AFFIDAVIT OF LEONARD I. LOFLIN

SHEARON HARRIS NUCLEAR POWER PLANT  
UNIT NOS. 1 AND 2  
DOCKET NOS. 50-400 AND 50-401  
DRAFT SAFETY EVALUATION REPORT RESPONSES

Shearon Harris Nuclear Power Plant  
Draft Safety Evaluation Report (DSER)  
Core Performance Branch  
Open Item 31 (DSER Section 4.4.8, pages 4-47, 4-49, & 4-50)

SHEARON HARRIS NUCLEAR POWER PLANT  
UNIT NOS. 1 AND 2  
DOCKET NOS. 50-400 AND 50-401  
RESPONSES TO REQUESTS FOR ADDITIONAL INFORMATION

Number: <b>F-0.2</b>	Title: <b>CORE COOLING</b>	Rev. Issue/Date: <b>HP/LP, REV. 1</b> <b>1 Sept., 1983</b>
-------------------------	-------------------------------	--

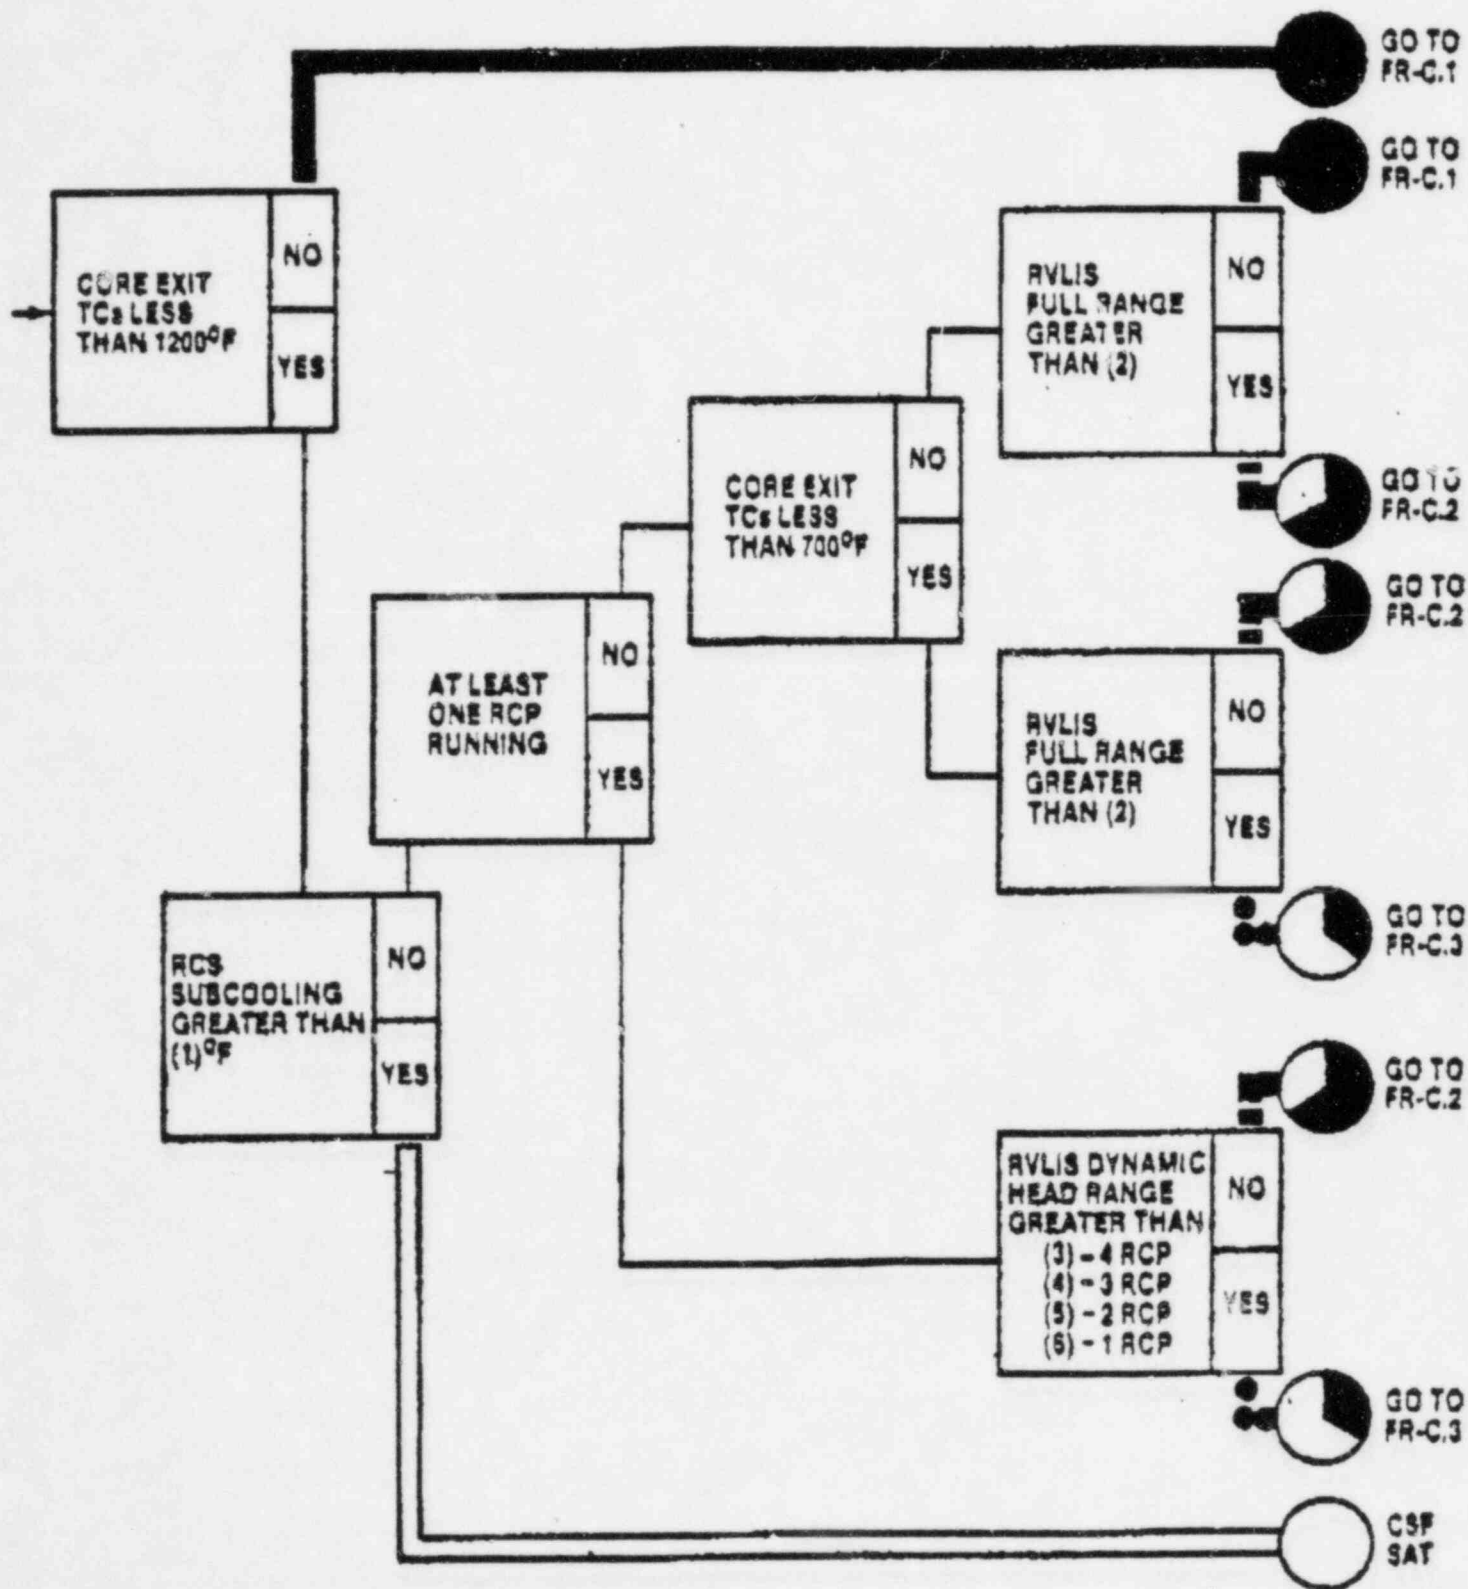
FRG C.1 This guideline will be used when indicated by the core cooling critical safety function status tree (refer to Attachment 1). The operator actions specified include:

FRG C.2 This guideline will be used when indicated by the core cooling critical safety function status tree (see Attachment 1).

FRG C.3 This guideline will be used when indicated by the core cooling critical safety function status tree (refer to Attachment 1).
